2CAN091401

SUBJECT: Response to Request for Additional Information
Containment Building Emergency Escape Air Lock Testing and Exemption
from Certain Requirements of 10 CFR 50, Appendix J
Arkansas Nuclear One, Unit 2
Docket No. 50-368
License No. NPF-6

Response to Request for Additional Information

Escape Hatch Seal Contact Check

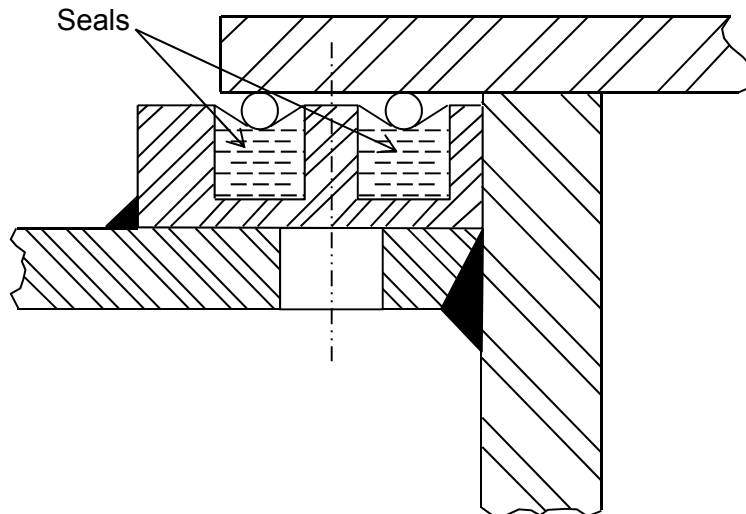
- (a) Please provide details about the test protocol that describe how the test pressure was supplied/applied.
- (b) Please justify why the test pressure was applied in the opposite direction of accident pressure (see fourth paragraph on page 5 of the attachment to the letter dated March 17, 2014).

- (c) Please explain whether the applied pressure in the between-the-seals-test would "lift" the door open or off its sealing surface leading to leakage.

- (d) Please summarize the efforts (investigations, modifications, maintenance) in terms of seal design, seal material, seal shape, seal operation conditions, door modifications, test methods etc. that have been considered or conducted to resolve the failure of between-the-seals pressure test cases. Also, please include a description of other gasket materials/profiles that may have been considered that could be qualified for the application that might form a better sealing joint (and more set resistant) without the need for strongbacks.

- (a) ANO uses a mass flowmeter to measure the door seal leakage. The leak rate test procedure states that the outlet (pressurization) valve is to be opened slowly to pressurize the test connection (door seals). Leak rate test protocol requires that the outlet pressure to be stable prior to recording leak rate data. Informational observations during initial pressurization of the door seals have identified leakage occurring at pressures much lower than the 10 psig test pressure. These observations supported vendor input that the existing door design is not suitable for a consistently successful door seal pressure test. Formal testing at alternative lower pressure is not performed.

- (b) The between-the-seals pressure test is limited by the door design and configuration of the seals. Since the seals are implanted into the stationary bulkhead frame, applying test pressure between the seals will act to push the door away from the stationary bulkhead and lift the door off of its contact position with the seals. Thus the design configuration does not present other options for performing between-the-seals testing such that forces would not be applied in the opposite direction of accident pressures.

- (c) The response to RAI-2(b) above describes the airlock design and the testing limitations that result in the between-the-seals test acting to push the door open, i.e., lift the door from its sealed position. The airlock doors are designed with a two point locking configuration to hold the doors in position. The two locking pins (located at 0° and 180°) are not designed to ensure doors are sealed with a force equivalent to accident pressure. These locking pins are designed to ensure the doors are in position and contacting the seals with limited sealing forces. Additional sealing forces are applied to the inner door as Containment Building pressure increases following accident initiation. If the inner door is postulated to leak during an accident, the airlock barrel would pressurize and provide additional sealing forces to the outer door.

The locking pin has been readjusted (with vendor oversight) on more than one occasion in the recent past in an attempt to apply the closing torque necessary to support a successful between-the-seals test. Inconsistent test results from the between-the-seal test indicate the test leads to leakage by applying forces in the direction to “lift” the door from its seating contact with the seals. Adjusting the locking pins to increase the door closing torque intended to improve test results, in turn, increases the force required to open the door for emergency egress significantly. Making the door more difficult to open is contrary to maintaining the airlock safety function for permitting personnel escape from the Containment Building during an emergency situation. The increased torque can lead to locking pin damage and can result in a jammed door.

- (d) As stated in the previous submittals, the seal material currently in use is an ethylene-propylene-diamine-monomer (EPDM), which is the vendor recommended and qualified material. The seals are a square cross-section shape design formed in a continuous circle to fit the bulk head frame seal channel. By design of the channel, the seal shape is limited. In addition, each door is designed with a “nose/sealing bar” that provides a continuous protrusion into the flat-faced seal for improved sealing contact (see diagram below). These features prevent seal design changes without extensive changes to the design and hardware of the hatch. The vendor has documented that the sealing limitations of the airlock design is related to the 2-pin latching configuration. Specifically,
